## Ducted Systems Technical Services: YS Letter

Letter: YS-006-21

Subject: **Reliability of modulating gas valve, factory directive concerning FC6, and change in warranty process regarding Critical Data Sheet requirement**

Product/s: Modulating Gas Furnace

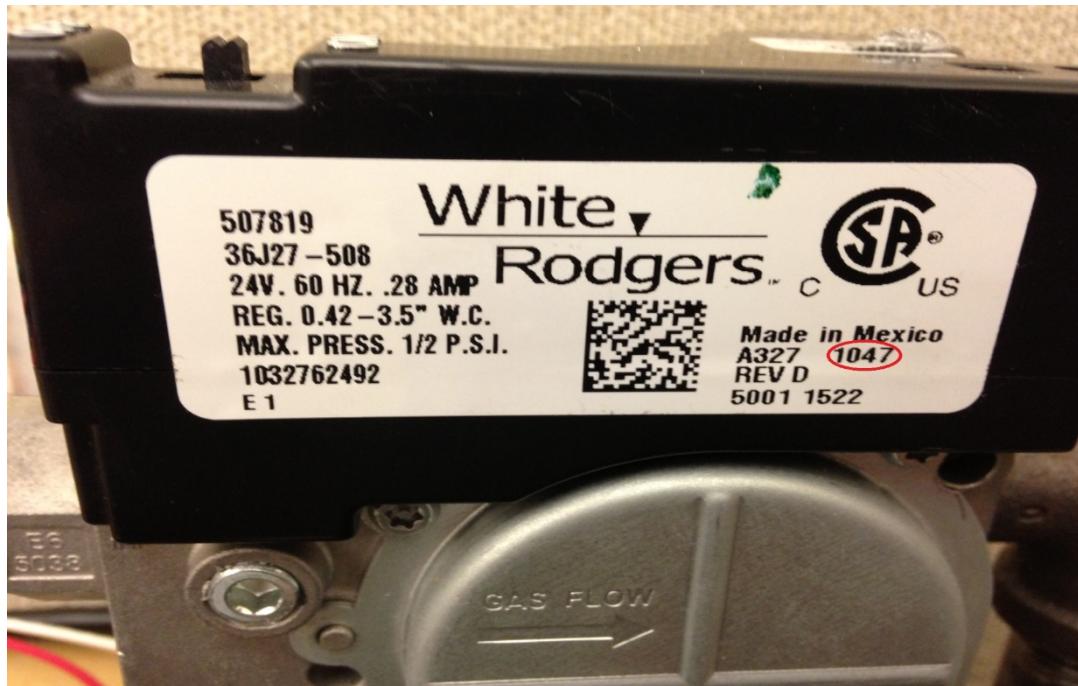
The reliability of the modulating gas valve has been factory monitored and verified to be drastically improved and is now at a fail rate on par with our standard 1 & 2 stage gas valves. This improvement was realized by a White Rogers redesign of the seating of the internal Drive Nut and Thrust Washer eliminating a stuck valve situation.

The redesign was introduced during the 28<sup>th</sup> week of 2017, unit serial number W1H7 or later. Revised gas valves will have the date code of 1728 or higher. The Source 1 part number of the valve has not changed.

The improvement is due to a machined groove in the actuator motor shaft that accepts an E-clip. The drive nut now seats against the E-clip eliminating all previous “clamping” and “compression” of the thrust washer.

Bottom line, if on a modulating gas furnace repair service call and **your diagnosis is indicating a stuck closed valve and the gas valve has a date code that** is earlier (smaller) than 1728, and ignition control software is SCD-1180 or later, change only the valve.

## ECM Ignition Control Board Software Version SCD-1162 vs SCD-1180, FC6 cause and correction

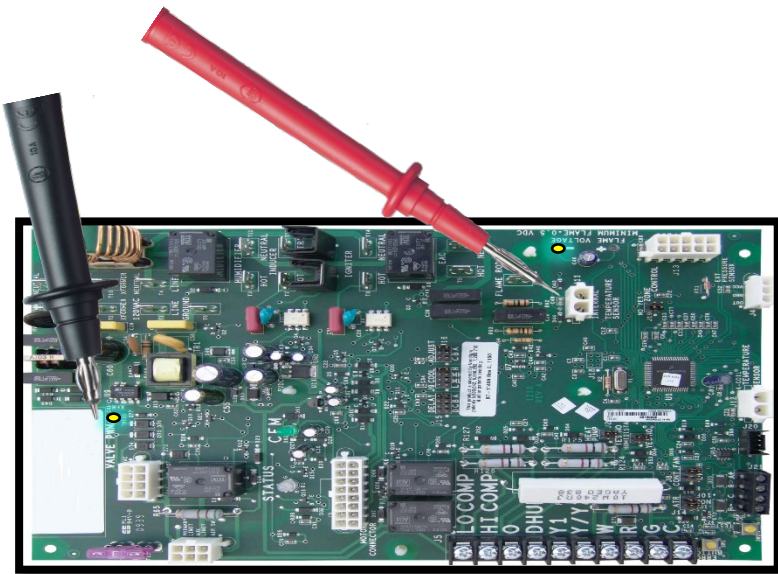
In 2015 an engineering decision was made to change the software in the ignition control board to SCD-1162 in an attempt to reduce or prevent modulating gas valve failures, as detailed in ST-020-15.

Previous versions of the ignition control software were believed to be a factor in gas valve failures. In those previous versions, the ignition control board software sent a “Home” command to the gas valve. The gas valve has its own “Home” command. The two “Home” commands to the gas valve were deemed to be redundant and problematic.

When software version SCD-1162 was introduced there was an immediate positive impact on gas valve failures but, there was a sudden uptick in complaints about FC6 codes which was defined as “Modulated Gas Valve Current Failure” on Gen 1 and is now defined as “Gas Valve Communication” in Gen 2. Due to the failure history of the gas valve, FC6 was errantly recognized to be an indication of a gas valve that was stuck closed, it is not.

FC6 was eventually recognized to be a high resistance electrical contact, for example, a higher than expected resistance across the Condensate Blocked Switch contacts. With a higher than normal resistance across its contacts, the switch could trigger the board to misidentify the event as an FC6 code. It was determined that SCD-1162 provided a too narrow of an acceptable resistance range across monitored contact points resulting in FC6 codes.

Software version SCD-1180 was released to eliminate the nuisance Fault Code 6 related to unexpected contact resistance.

After you have determined the reason for the fault code 6 and if you find that the ignition control board has a software version that is lower than SCD-1180, replace the board.
